September 30, 2016

04934 Version 1

## Rubbing, Popping or Clicking From Front Door When Opening

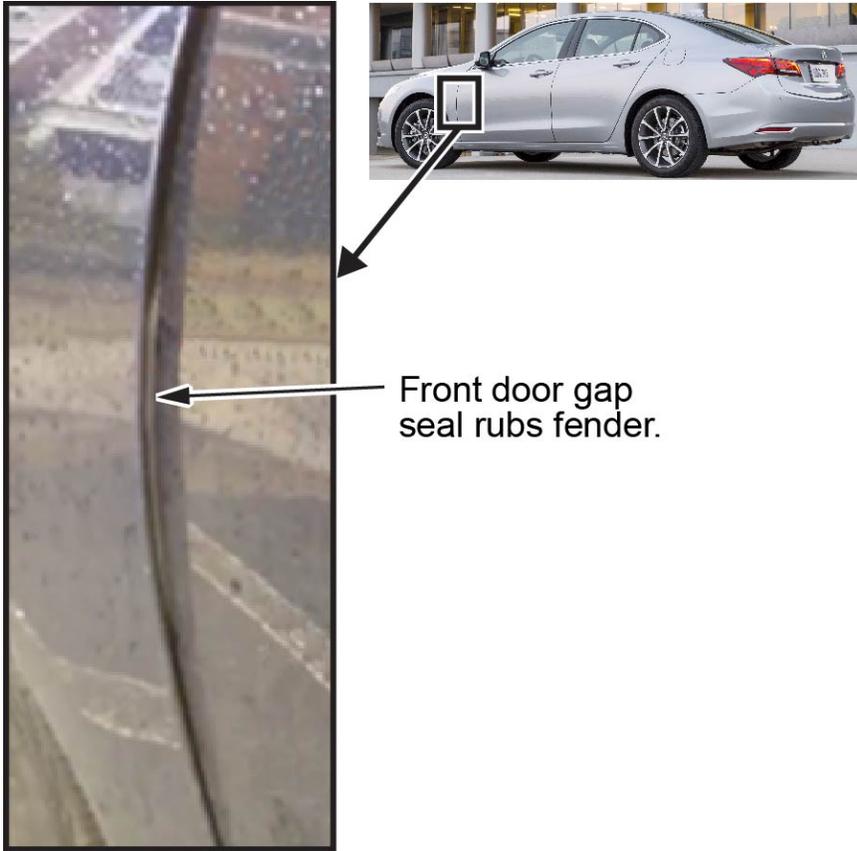
The door gap seal, on the leading edge of the front doors contacts and rubs against the front fender when opening the door.

Identify the side making the noise, and replace the front door gap seal on that affected side. **Do not** adjust the door or fender to resolve the noise because it may cause a road or wind leak noise inside the cabin.

Part Name	Part Number	Quantity
Right Side Front Door Gap Seal	72336-TZ3-A02	1
Left Side Front Door Gap Seal	72376-TZ3-A02	1
